UNITED STATES PATENT AND TRADEMARK OFFICE

APPLICATION NO.	FILING DATE	FIRST NAMED INVENTOR	ATTORNEY DOCKET NO.	CONFIRMATION NO.
10/725,577	12/03/2003	Manabu Suzuki	1081.1186	3453

Office Action Summary

DETAILED ACTION

Fig. 1 PRIOR ART

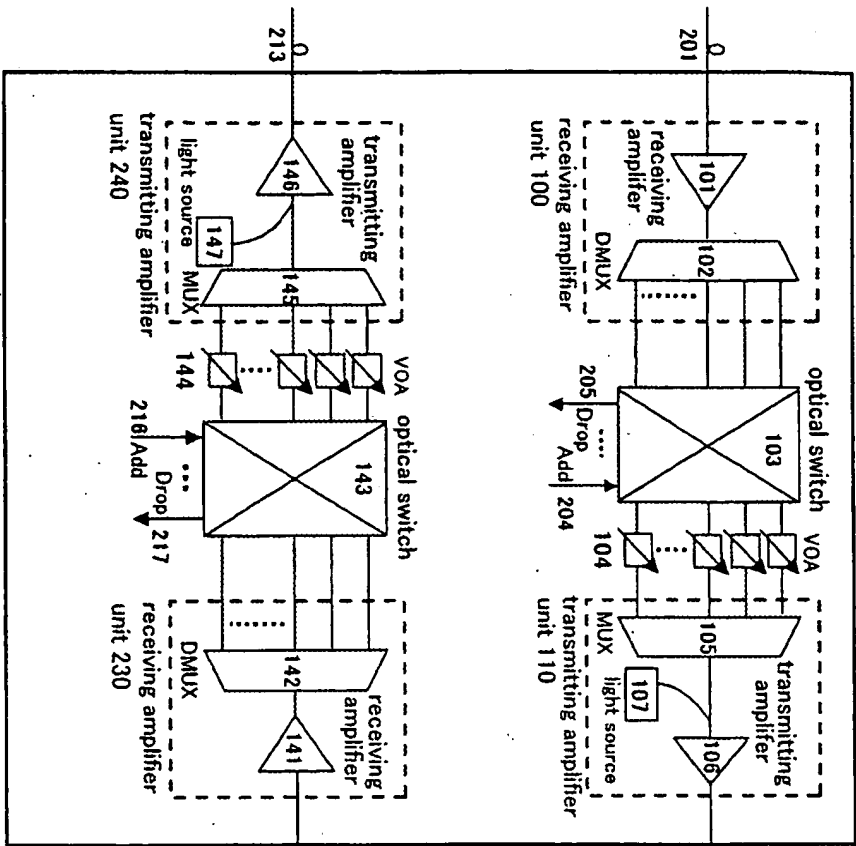
1. Applicant's response to the objections to the drawings in the previous Office Action (mailed on 26 September 2006) is noted and appreciated. Applicant responded by amending Figs. 1 and 10. These drawings are approved. However, the drawings are still objected to because of the following:
